CITY OF CONWAY, ARKANSAS HISTORIC DISTRICT COMMISSION

June 26, 2023 • 5:30pm • 1111 Main Street

1504 Prince Street - Remodel and Addition

2115 Hickory Street - Remodel and Addition

Front Elevation

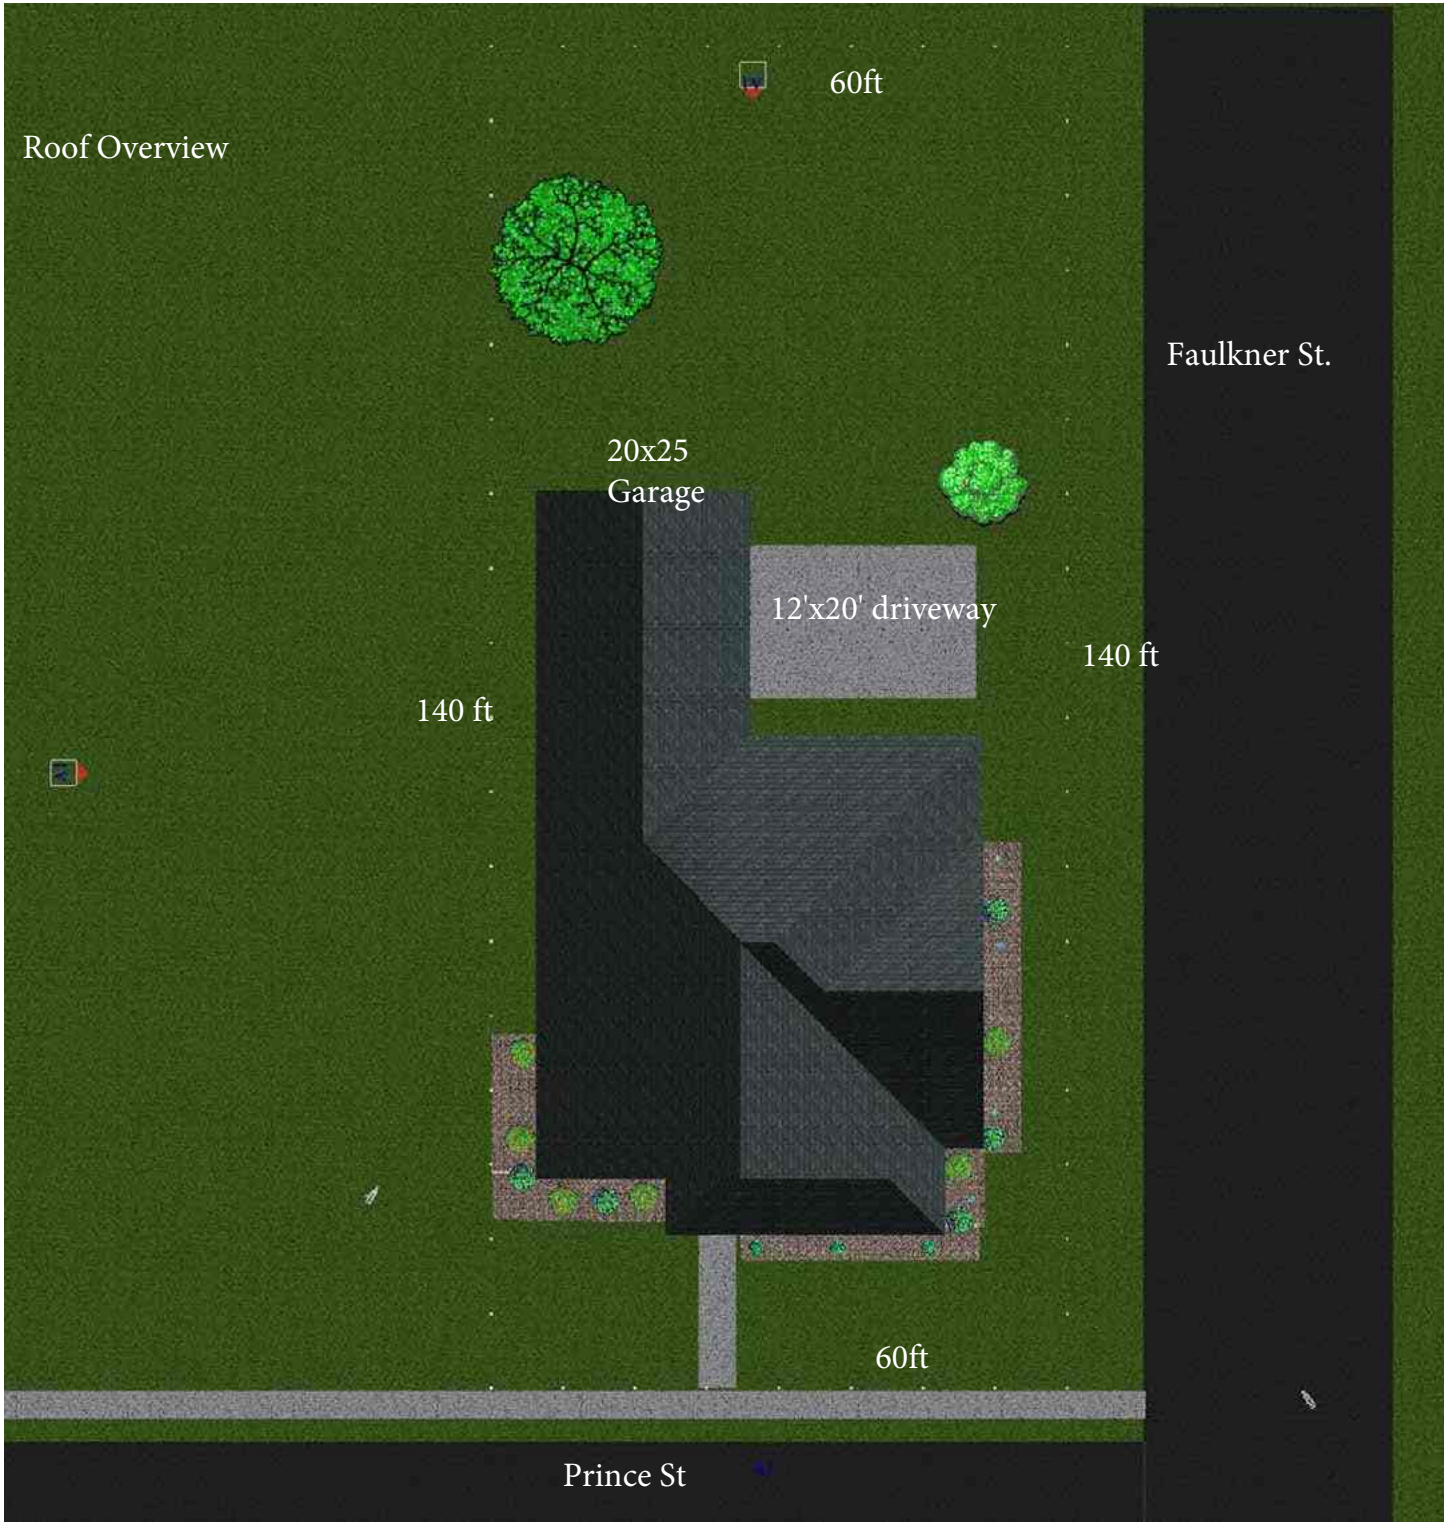
Applicant is proposing a 20’x25’ attached garage behind the residence. It will match the materials and color of the residence.

Through consultation with Iain Montgomery (AHPP), staff has determined that an addition of this size and type would impact the residence’s “contributing” status.

The applicant is proposing a porch addition. The definition of "addition" states: "New construction added to an existing building or structure."

The applicant proposes extending the roofline to fill in an area on the north side of the property and construct a back porch. The roofing material will match the residence and the columns will match those on the front porch. Research throughout the district has indicated that additions do not necessarily result in a non-contributing status. The residence at 1709 Prince St is contributing with a comment which reads: "Back L addition has been added since 1998 survey. Excellent restoration and sensitive addition."

2. HVAC unit shall be screened from the public right-of-way through its positioning in relation to other structures or through vegetative cover.
3. Porch addition shall have columns which match those on the front porch.

11. Siding shall be vinyl, Hardie® siding or wood.
12. The existing garage may be demolished. Applicant shall secure proper permits for demolition.
13. Deny approval of the attached garage as proposed.

Proposed attachment detail

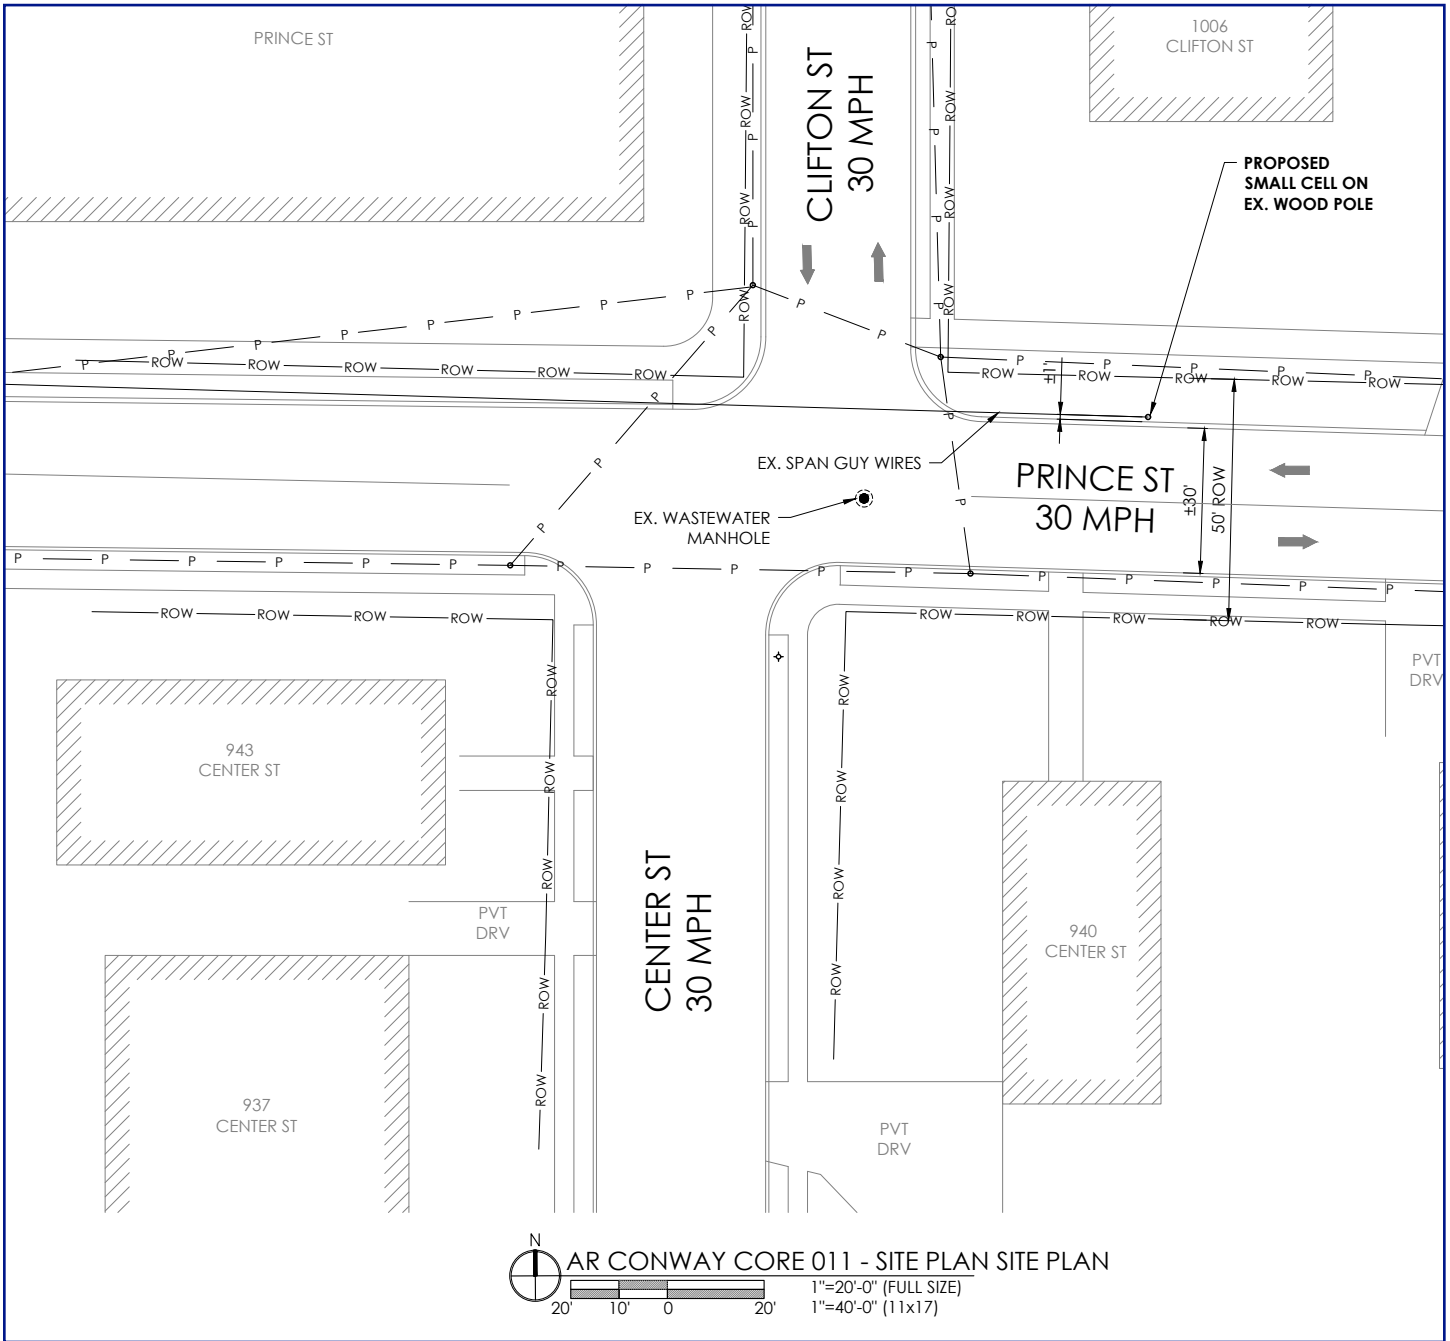
General Description of Property and Proposed Development. The applicant is proposing to install a small cellular antenna on an existing wooden utility pole in the Robinson Historic District. This is to connect Verizon 5G services to this area of Conway. They will also be installing an electrical meter and disconnect on the proposed pole.

The structure will consist of an omni-directional antenna mounted at the top of the pole. Total height after installation will be 28'. A 3' cabinet will be installed near the top of the pole and the meter base and disconnect will be roughly 6' from ground. All wiring will be contained in either guards or conduit to improve the appearance of the structure.

Staff recommends approval of the colocation of the small cellular antenna and accompanying equipment. Applicant shall secure required permits for installation.

② LEFT
1/4" = 1'-0"

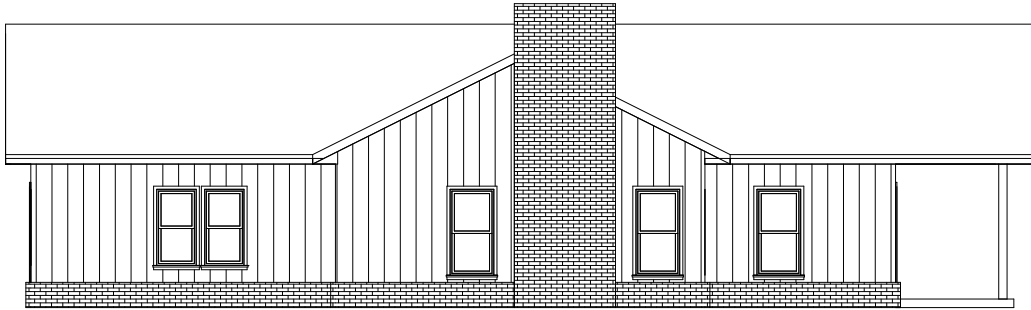
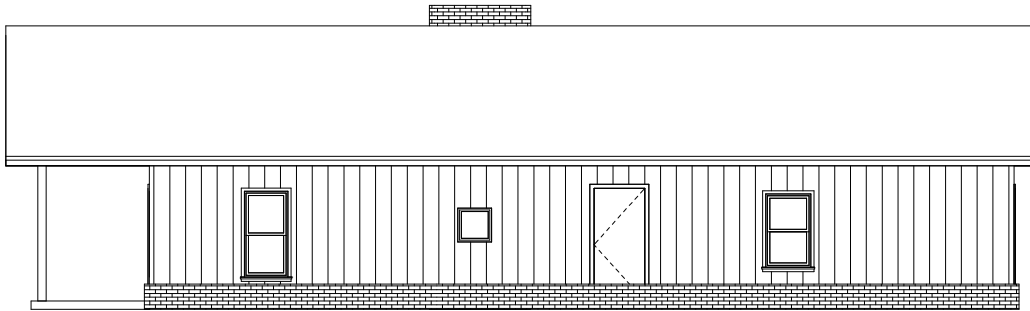
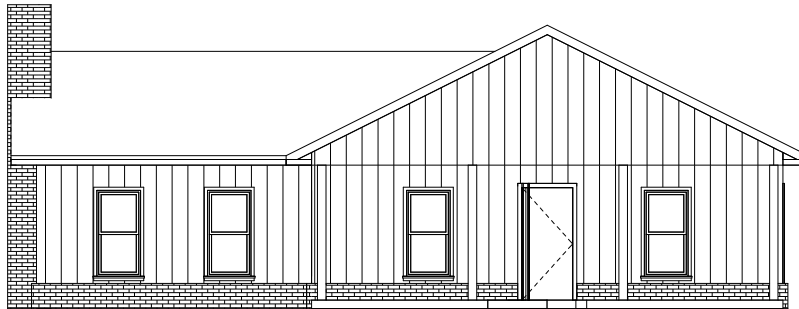
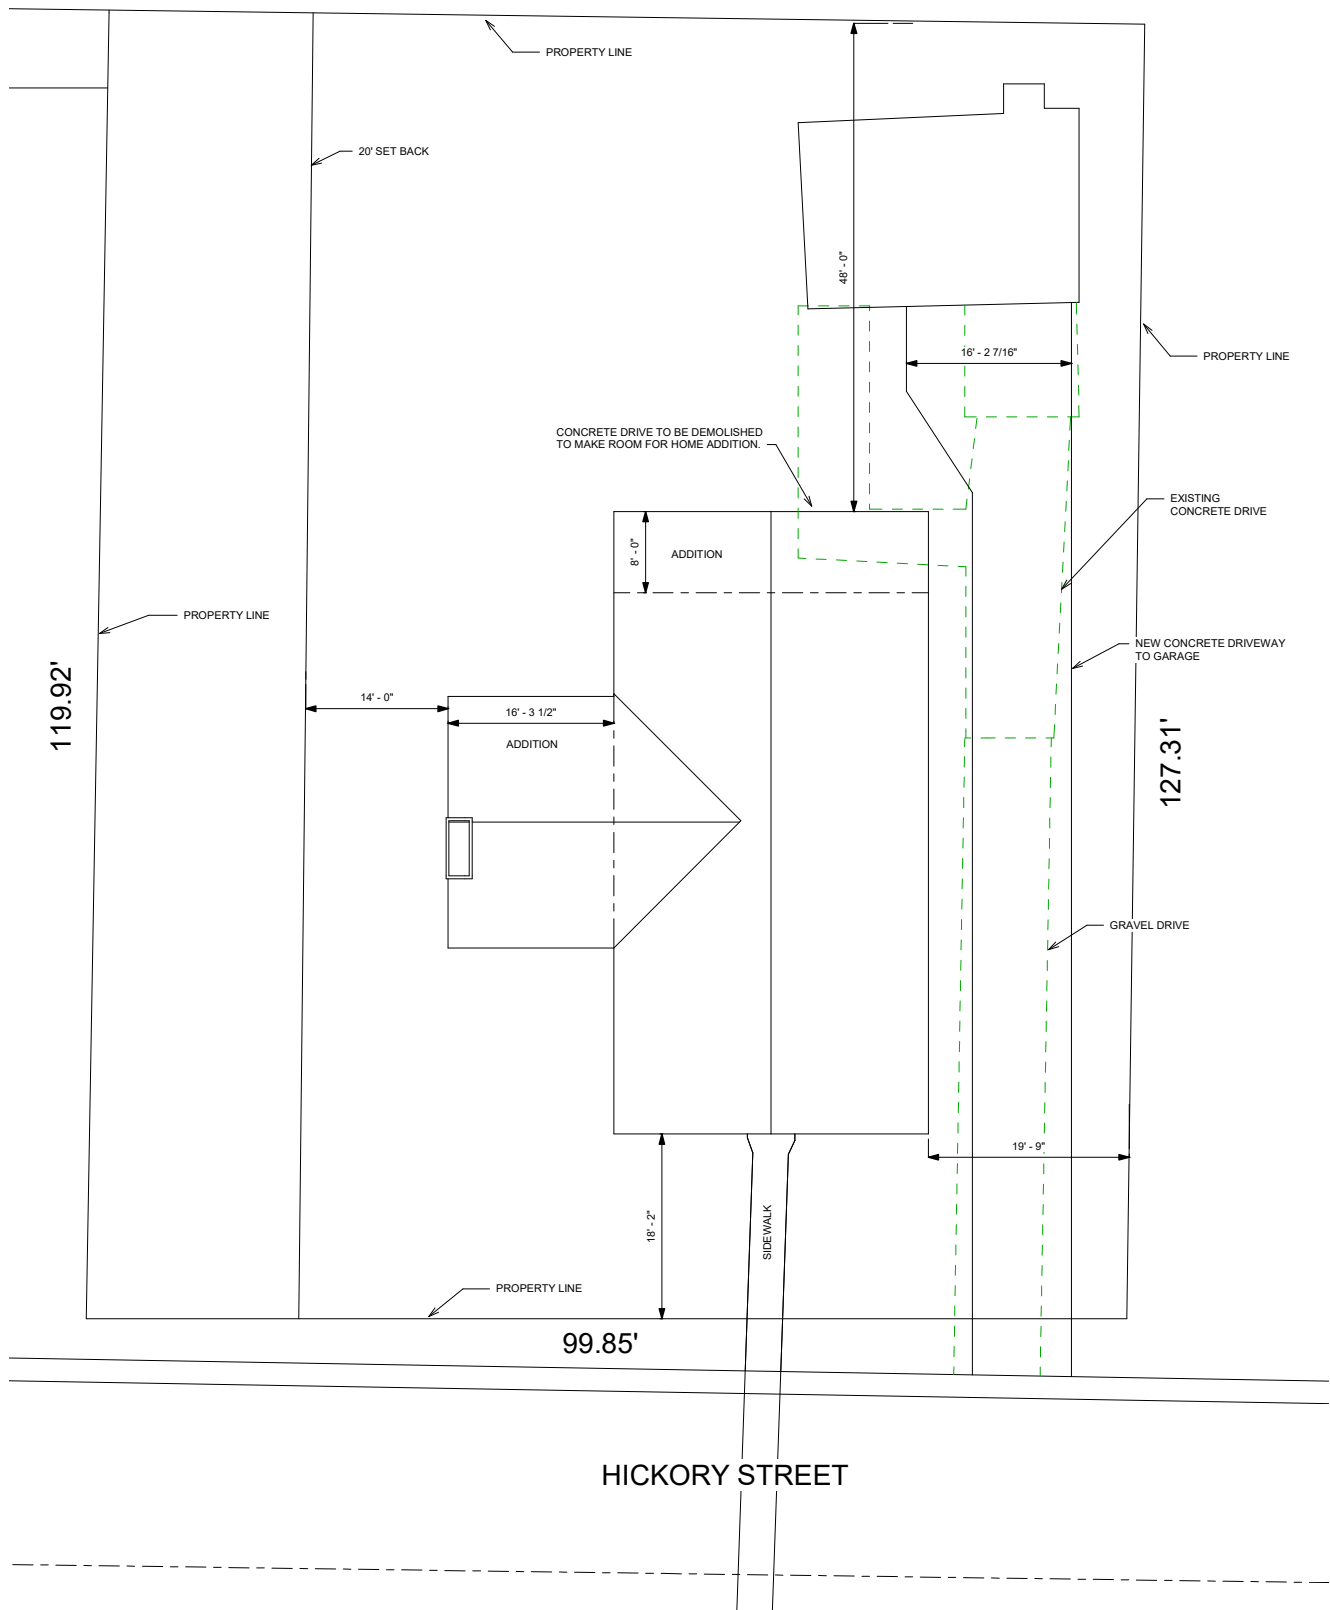
Proposed addition contains two street facing windows which follow the same rhythm as the primary residence.

No changes to the porch are proposed. Proposed windows are one-over-one and a single picture window which will face the side yard. Considering that the residence was built in 1952 and the picture window will not face the street, the picture window is appropriate.

Applicant proposes Hardie® board & batten siding with brick accents.

Reroofing is proposed. The addition will also extend the roofline towards the east. The proposed design maintains a gable style. Existing roof is metal so applicant may replace in kind or use architectural shingles as proposed.

1. Applicant must obtain all applicable building permits* if/when a Certificate of Appropriateness is granted.
**Applicant shall provide proof of appropriate licensure of professionals performing work to the Building Permits Department.*
2. All windows should be one-over-one (except for the single picture window above the kitchen sink.) If divided light windows are used, they shall be true divided light as fake muntin bars are prohibited.
3. No shutters shall be allowed.
4. Siding on residence, addition and garage shall be Hardie® siding or wood.
5. Skirt and chimney shall be brick
6. Roof on residence, addition and garage shall be metal or composition shingles.
7. Driveway shall be composed of concrete or permeable pavers.

Changes proposed to approved design

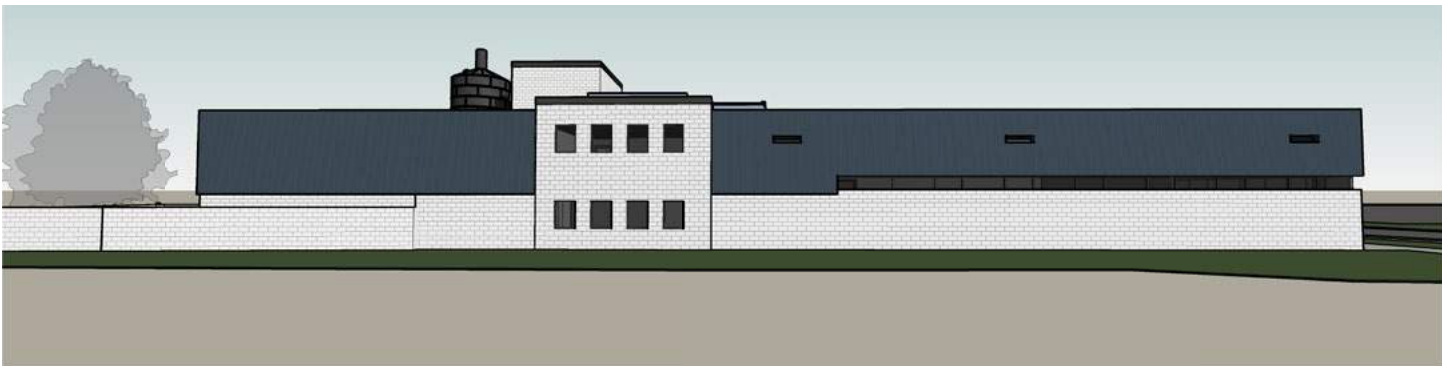
No fencing, railings or walls are proposed along College Ave. A fence is proposed surrounding an outdoor pickleball court along Front St, but the fence material is not noted. While the use of the fence is appropriate to delineate the private pickleball court from the abutting public pedestrian pathway, the applicant needs to provide proposed fencing material and alter design so that the fencing is at least 70% open.

There is no alley access to this lot. The applicant is proposing one curb cut at approximately mid-block on Front St which appears to be 20' in width. The applicant shall confirm that the curb cut does not exceed 20' in width.

Floor plans and elevations are unclear regarding windows on the east and south elevations. Staff requests confirmation that there are windows at approximately the ceiling of the 1st floor. Additionally, the façade would benefit from the addition of windows at the ground floor private dining area. If there is a row of windows along the first floor ceiling, as seen as a strip on the east and south elevations, the applicant will only need to provide additional windows for the private dining area. Otherwise, there will need to be windows added to the game room area. The addition of the windows to the private dining area will provide more rhythm to the façade, however, additional building materials and/or windows should be added along that railroad perspective to enhance that rhythm.

Applicant shall confirm that proposed glazing meets transparency requirements. In addition to glass, the applicant is proposing to apply stucco over the existing CMU. Material must be a true stucco material, not EIFS. The following is a list of proposed materials:

6. 85% of all first story glazing shall be transparent.
7. Prior to issuance of a Certificate of Appropriateness, **the applicant shall provide Planning and Development with updated drawings showing:**

- a. The inclusion of additional windows at the private dining area.
 - b. Description of windows/materials along the 1st first floor ceiling at the game room and private dining area

- c. Updated façade design which breaks up the monolithic appearance of the railroad easement perspective.
8. All signage shall comply with Old Conway Overlay District guidelines and regulations detailed in Article XII of the Conway Zoning Code. All signage is permitted separately from all review and building permit processes.

① EAST ELEVATION (FRONT)
1/4" = 1'-0"

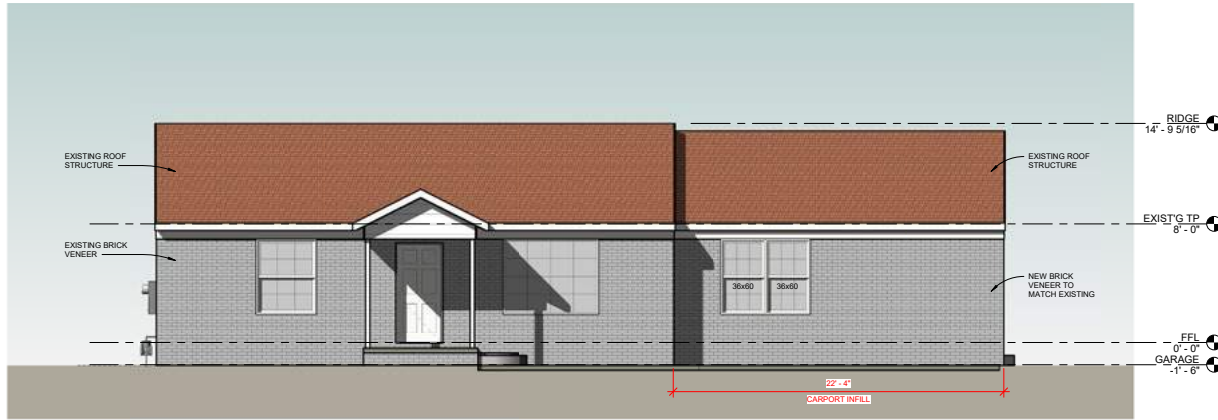
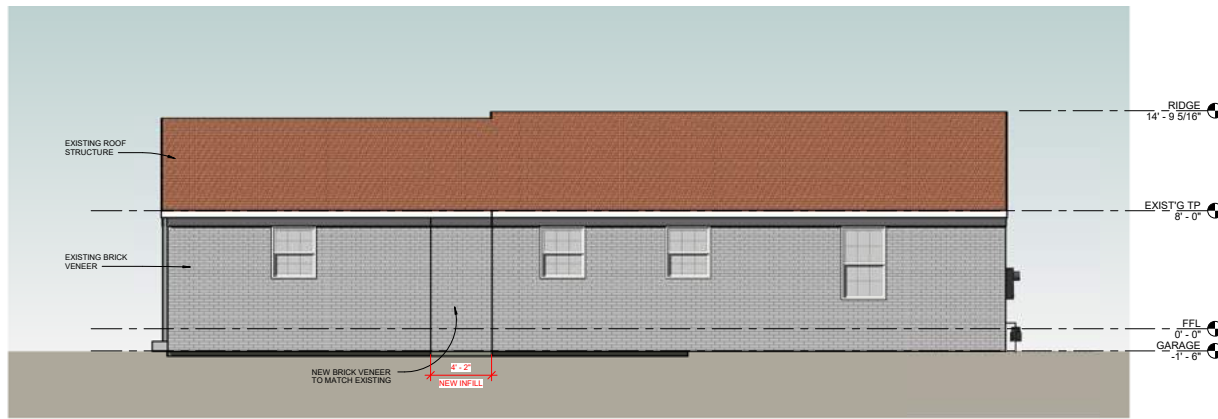
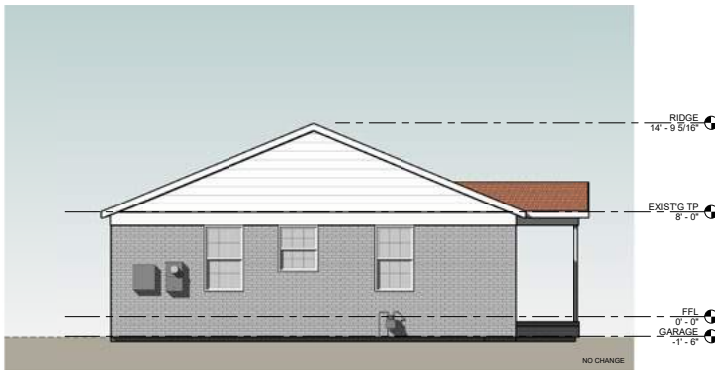
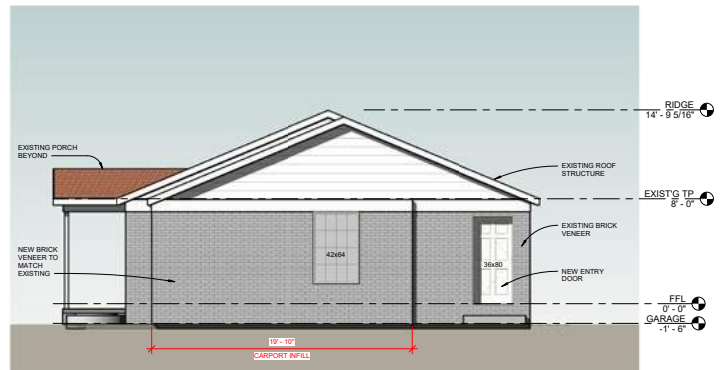
Architectural Details, Siding, and Bricks. Detailing and siding should complement the surrounding area. Siding should include brick, stone, wood, or Hardie® siding/LP® SmartSide® type siding.
The exterior of the addition will have brick to match the existing residence. No other details and siding are listed in the project description or on floor plans/elevations.

The proposed addition is to the side of the residence but is an infill of an existing carport and therefore does not alter the footprint or roofline of the existing structure.

1. Applicant must obtain all applicable building permits* if/when a Certificate of Appropriateness is granted.
**Applicant shall provide proof of appropriate licensure of professionals performing work to the Building Permits Department.*
2. Prior to issuance of Certificate of Appropriateness, **applicant shall provide Planning and Development with an updated site plan** showing two parking spaces. These spaces shall be comprised of concrete or pavers (the driveway can serve as parking).
3. Prior to issuance of certificate of completion, the driveway shall be concrete, permeable pavers, or a ribbon.
4. All windows should be six-over-six, true divided light. Fake muntin bars are prohibited.
5. No shutters shall be allowed.
6. Siding on residence and addition shall be brick.
7. Roofing material shall be composition or asphalt shingles.
